PROPOSED FIX TO STREAM RESTORATION PROTOCOL 3

USWG – August 15, 2023

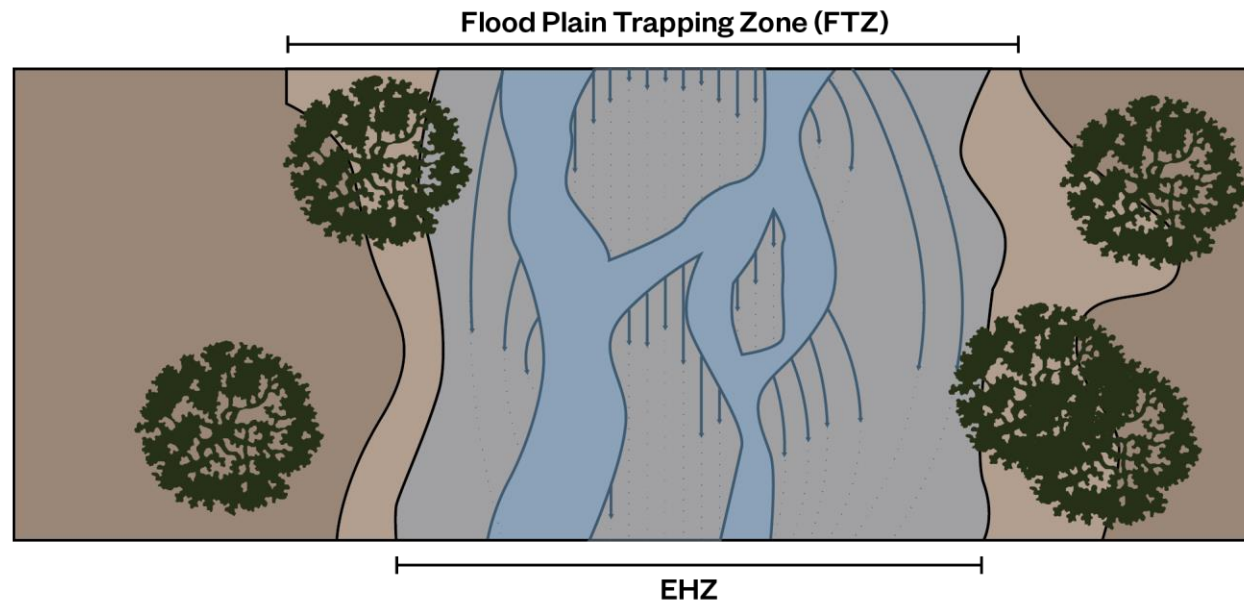
- New Protocol 3 may not properly “scale” the credit to account for more or less extensive floodplain restoration projects (whether by length or acres of reconnected floodplain).

- Lack of support for relaxing the crediting cap that limited nutrient and sediment reductions to the first one foot of water on the floodplain in certain circumstances for projects that otherwise meet the qualifying conditions.
